Workgroup Consultation	At what stage is this document in the process?												
<h1>GC0127 & GC0128:</h1> <p>Mod Title: EU Code Emergency & Restoration: Requirements resulting from System Defence and Restoration Plans</p>

This Workgroup Consultation contains the discussion of the Workgroup which formed in May 2019 to develop and assess the proposals. This Consultation document covers both modification GC0127 and GC0128.

Figure ECC.6.3.3(a) **Active Power Output with falling frequency for Power Generating Modules and HVDC Systems and Electricity Storage Modules when operating in an exporting mode of operation**

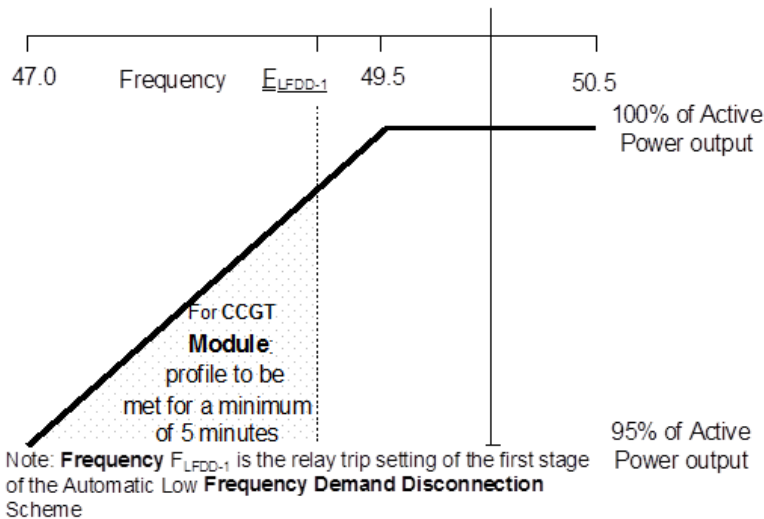
(b) (subject to the provisions of ECC.6.1.2) maintaining its **Active Power** output at a level not lower than the figure determined by the linear relationship shown in Figure ECC.6.3.3(a) for **System Frequency** changes within the range 49.5 to 47 Hz for all ambient temperatures up to and including 25°C, such that if the **System Frequency** drops to 47 Hz the **Active Power** output does not decrease by more than 5%. In the case of a **CCGT Module**, the above requirement shall be retained down to the **Low Frequency Relay** trip setting of 48.8 Hz, which reflects the first stage of the Automatic Low **Frequency Demand Disconnection** scheme notified to **Network Operators** under OC6.6.2. For **System Frequency** below that setting, the existing requirement shall be retained for a minimum period of 5 minutes while **System Frequency** remains below that setting, and special measure(s) that may be required to meet this requirement shall be kept in service during this period. After that 5 minutes period, if **System Frequency** remains below that setting, the special measure(s) must be discontinued if there is a materially increased risk of the **Gas Turbine** tripping. The need for special measure(s) is linked to the inherent **Gas Turbine Active Power** output reduction caused by reduced shaft speed due to falling **System Frequency**. Where the need for special measures is identified in order to maintain output in line with the level identified in Figure ECC.6.3.3(a) these measures should be still continued at ambient temperatures above 25°C maintaining as much of the **Active Power** achievable within the capability of the plant. **For the avoidance of doubt, Generators in respect of Pumped Storage Plant and Electricity Storage Modules shall also be required to satisfy the requirements of OC6.6.6.**

Figure ECC.6.3.3(a) Active Power Output with falling frequency for Power Generating Modules and HVDC Systems and Electricity Storage Modules when operating in an exporting mode of operation

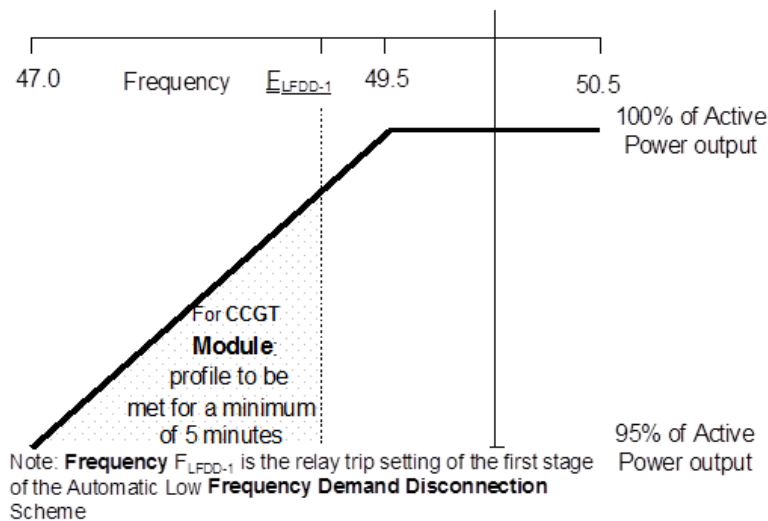
- (b) (subject to the provisions of ECC.6.1.2) maintaining its **Active Power** output at a level not lower than the figure determined by the linear relationship shown in Figure ECC.6.3.3(a) for **System Frequency** changes within the range 49.5 to 47 Hz for all ambient temperatures up to and including 25°C, such that if the **System Frequency** drops to 47 Hz the **Active Power** output does not decrease by more than 5%. In the case of a **CCGT Module**, the above requirement shall be retained down to the **Low Frequency Relay** trip setting of 48.8 Hz, which reflects the first stage of the Automatic Low **Frequency Demand Disconnection** scheme notified to **Network Operators** under OC6.6.2. For **System Frequency** below that setting, the existing requirement shall be retained for a minimum period of 5 minutes while **System Frequency** remains below that setting, and special measure(s) that may be required to meet this requirement shall be kept in service during this period. After that 5 minutes period, if **System Frequency** remains below that setting, the special measure(s) must be discontinued if there is a materially increased risk of the **Gas Turbine** tripping. The need for special measure(s) is linked to the inherent **Gas Turbine Active Power** output reduction caused by reduced shaft speed due to falling **System Frequency**. Where the need for special measures is identified in order to maintain output in line with the level identified in Figure ECC.6.3.3(a) these measures should be still continued at ambient temperatures above 25°C maintaining as much of the **Active Power** achievable within the capability of the plant. For the avoidance of doubt, Generators in respect of Pumped Storage Plant and Electricity Storage Modules shall also be required to satisfy the requirements of OC6.6.6.
